# Access Compliance Report

## Public Rights-of-Way

### (Curb Ramps)

Intersection ID: N/A	Main Street: WAVERLY_WALK_AV	Cross Street: MATTHEWS_FARM_LN	Location: NW
ADA ID: D2FCD8186B34	Ramp Type: Perp	Initial Pass/Fail: Fail	Overall Compliance: No
		Severity Score: 1.25

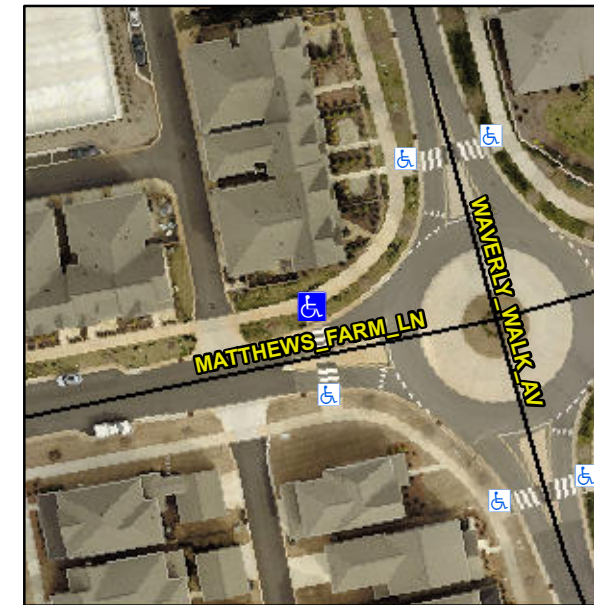
**Not Found, R304.5.3**

Compliance	Description	Data	Compliance	Description	Data
N/A	Ramp Length (in)	96.0	Yes	Ramp Slope (%)	6.2
Yes	Ramp Width (in)	112.0	No	Ramp XSlope (%)	3.7
N/A	Flare Type LT	N/A	N/A	Flare Type RT	N/A
N/A	Flare Slope LT (%)	N/A	N/A	Flare Slope RT (%)	N/A
N/A	Flare Traversable LT?	N/A	N/A	Flare Traversable RT?	N/A
N/A	Landing Length (in)	N/A	N/A	DWS Provided?	N/A
N/A	Landing Width (in)	N/A	N/A	DWS Contrast?	N/A
N/A	Landing Slope (%)	N/A	N/A	DWS Length (in)	N/A
N/A	Landing X Slope (%)	N/A	N/A	DWS Full Width?	N/A
N/A	Landing Curb? (Y/N)	N/A	N/A	DWS Offset (in)	N/A
N/A	Shared Landing?	N/A			
N/A	Gutter Ponding?	N/A	N/A	Gutter Slope (%)	N/A
N/A	Gutter Lip Ht (in)	N/A	N/A	Gutter X Slope (%)	N/A
N/A	Painted X Walk1?	Yes	N/A	Painted X Walk2?	N/A
	X Walk 1 Direction	To S		X Walk 2 Direction	N/A
N/A	X Walk 1 Width (in)	121.0	N/A	X Walk 2 Width (in)	N/A
	X Walk 1 Slope (%)	0.5		X Walk 2 Slope (%)	N/A
	X Walk 1 X Slope (%)	1.1		X Walk 2 X Slope (%)	N/A

**Remove & Replace Entire Ramp.**
